Re: Class 3 Permit Modification Technical Notice of Deficiency Letter Response
Shell USA, Inc. – Deer Park, Harris County
Hazardous Waste Permit No. 50099
Industrial Solid Waste Registration No. 30007
EPA Identification No. TXD067285973
Tracking No. 29917021; RN100211879/CN601542012

On behalf of Shell USA, Inc, this letter is to provide responses to the referenced Technical NOD in your letter dated November 14, 2024. Specific to each NOD, our responses are as follows:

**Subject: Shell SET Front Ends Project – West Basin & Offsite Areas
Preliminary Settlement Estimate**

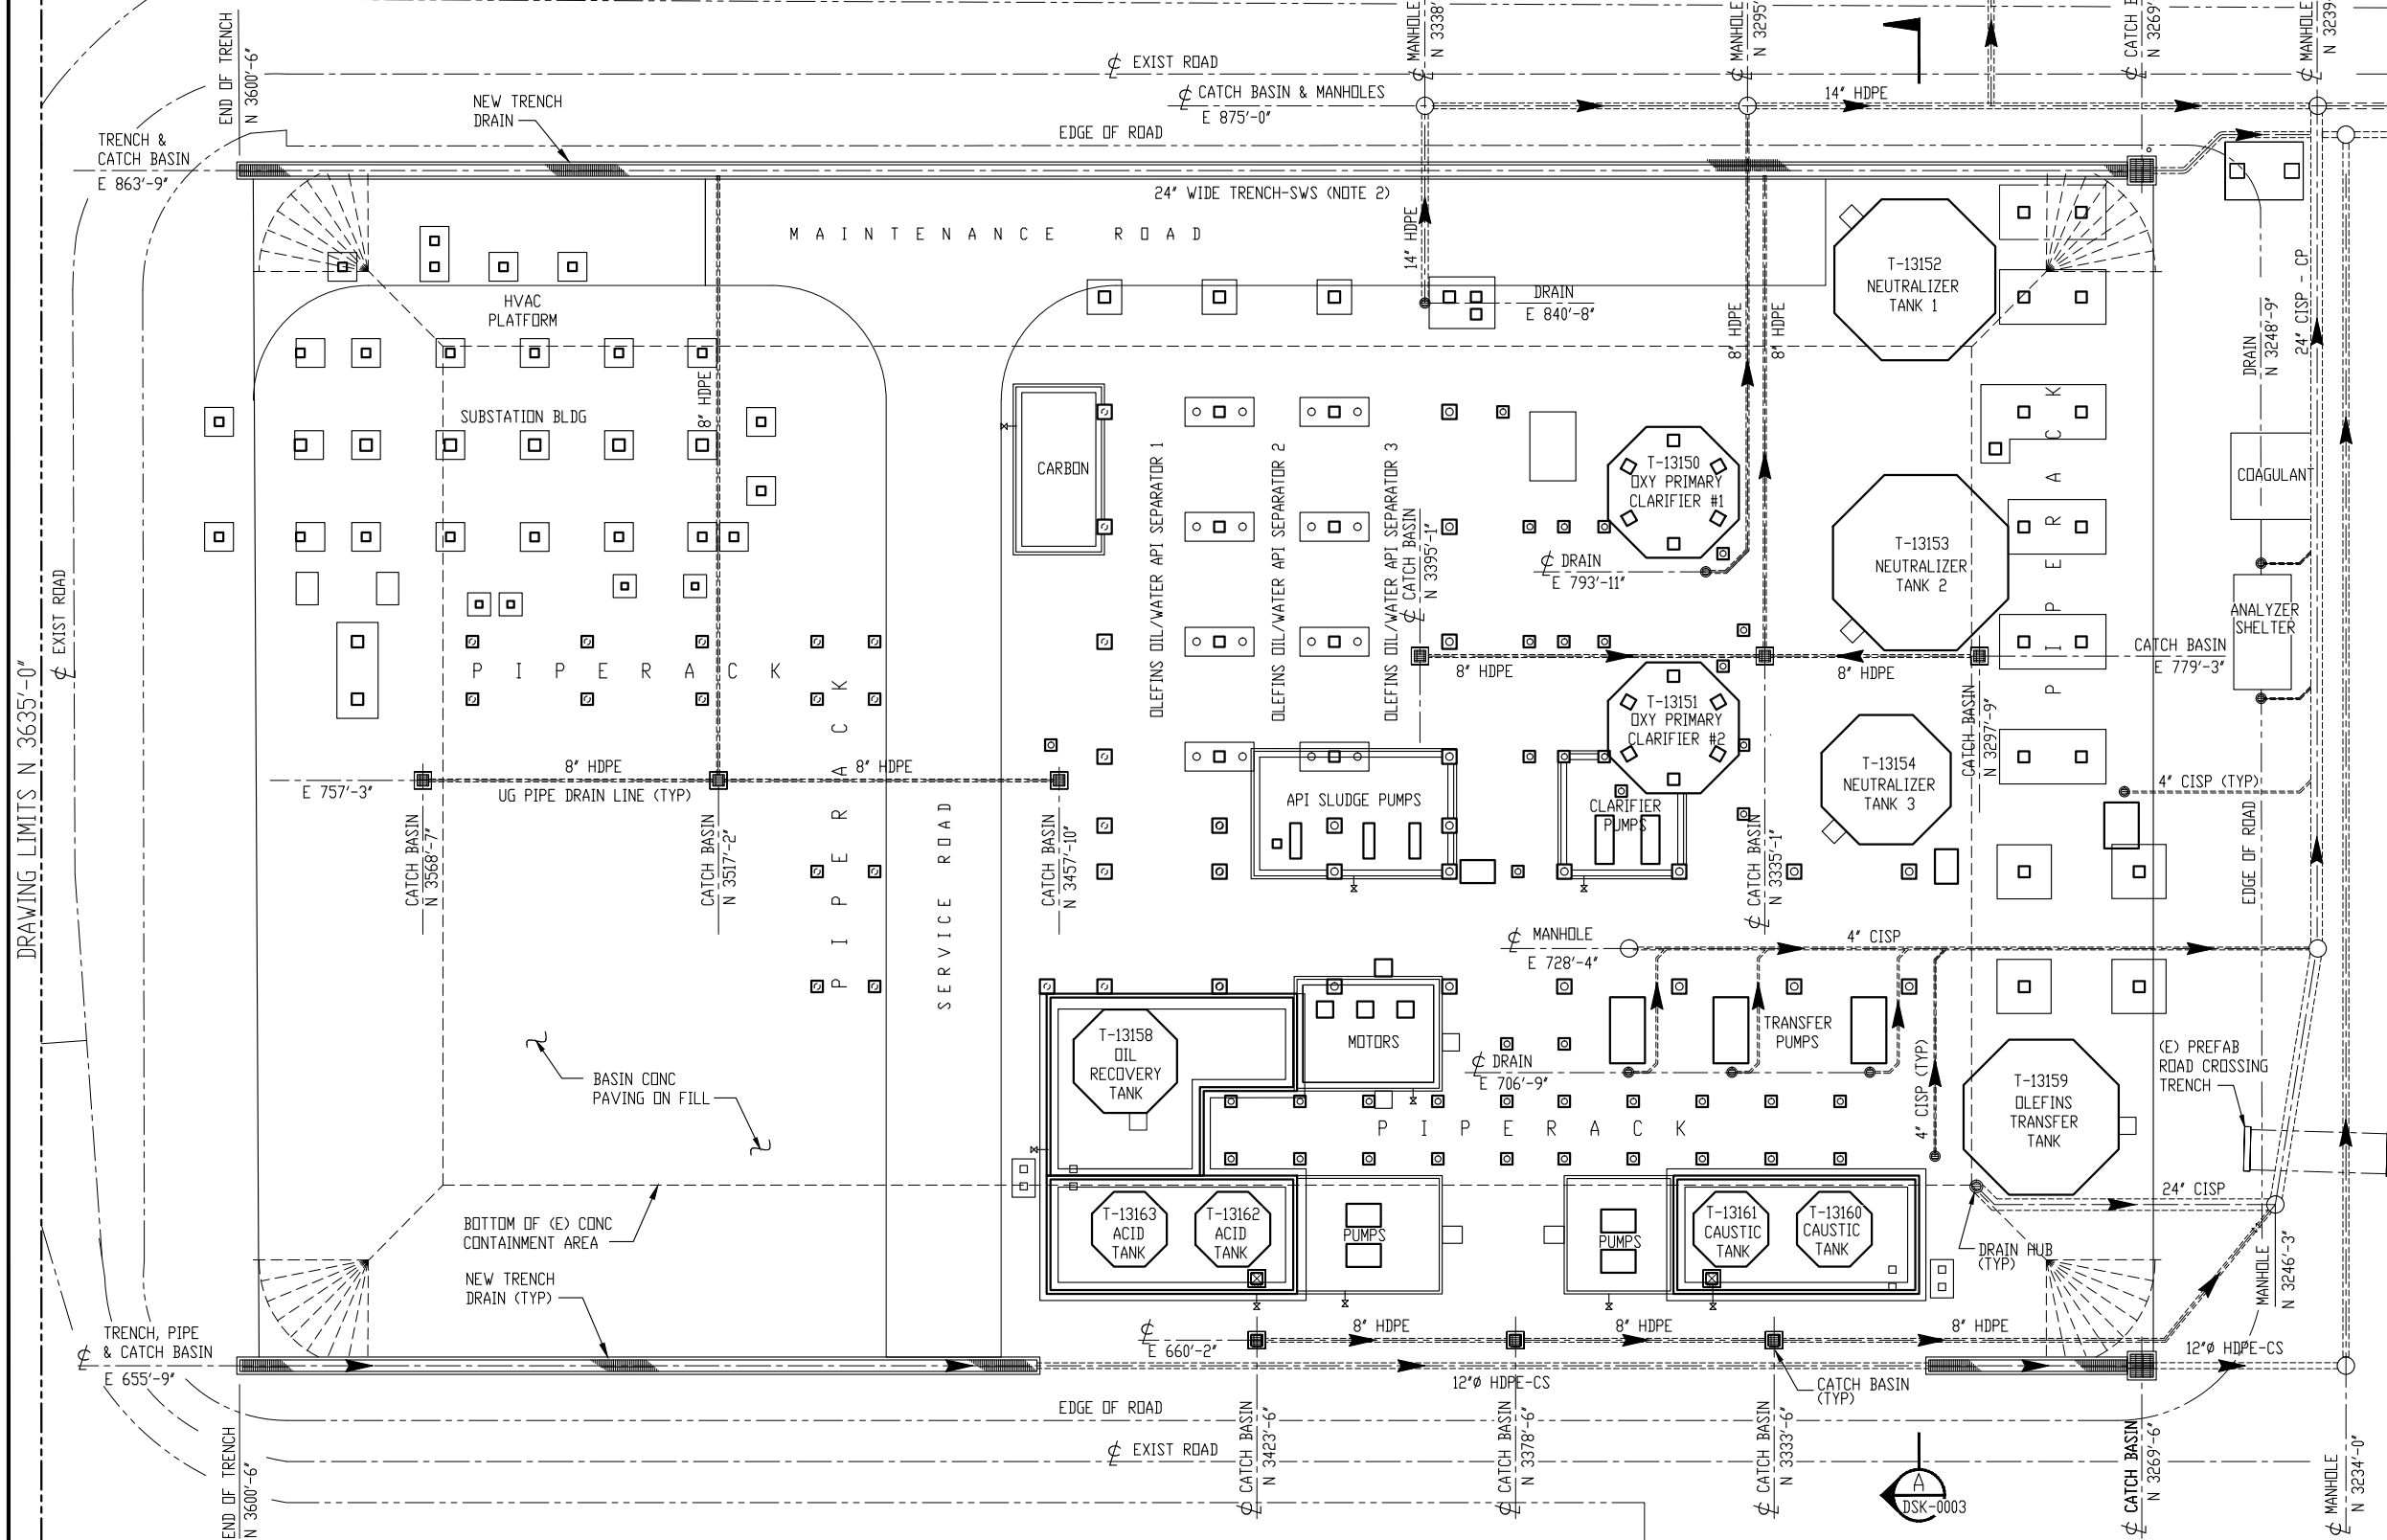
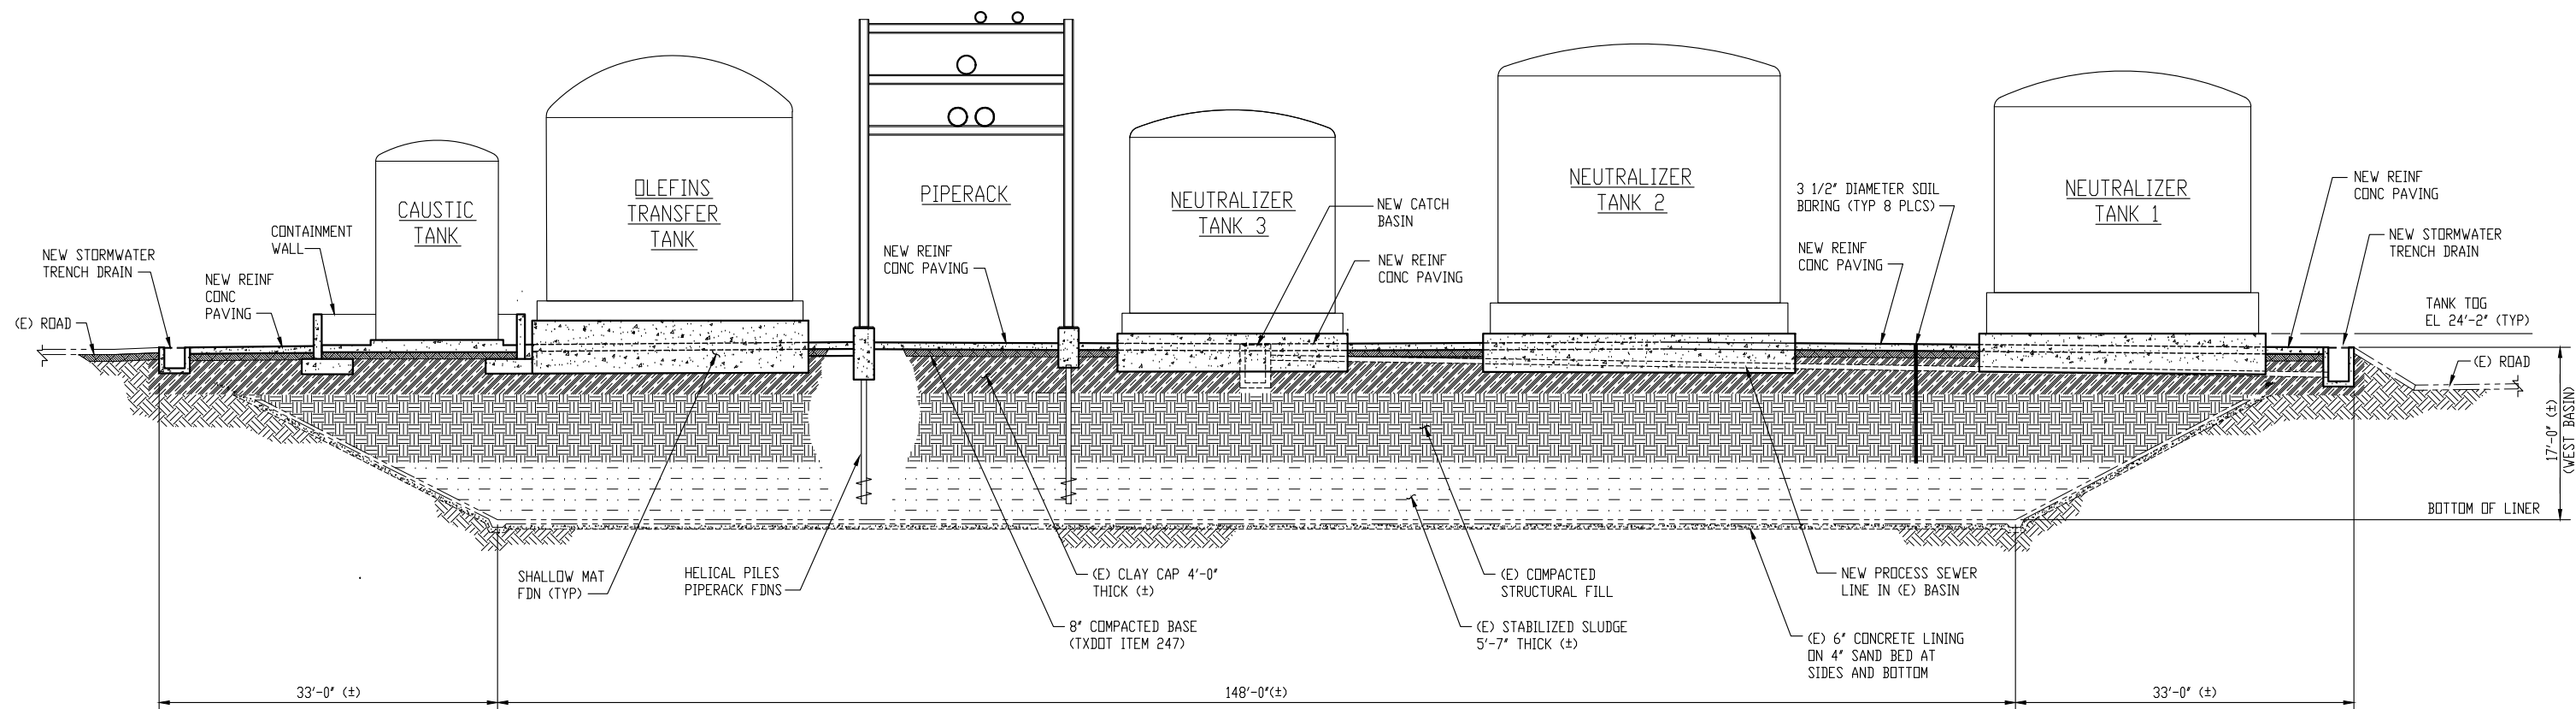
T5.2 Revise the closure plan for the West SET Basin to provide the design drawings (plan and cross-sectional views) for the final cover system that is sealed, signed, and dated by a Texas licensed P.E. as well as the engineering firm registration number (if applicable) required by the Texas P.E. board.

Response: The revised drawings are attached and will be incorporated into the revised Section V, 2025 cap modification plan (under revision) and Section VII revised closure plan (under construction).
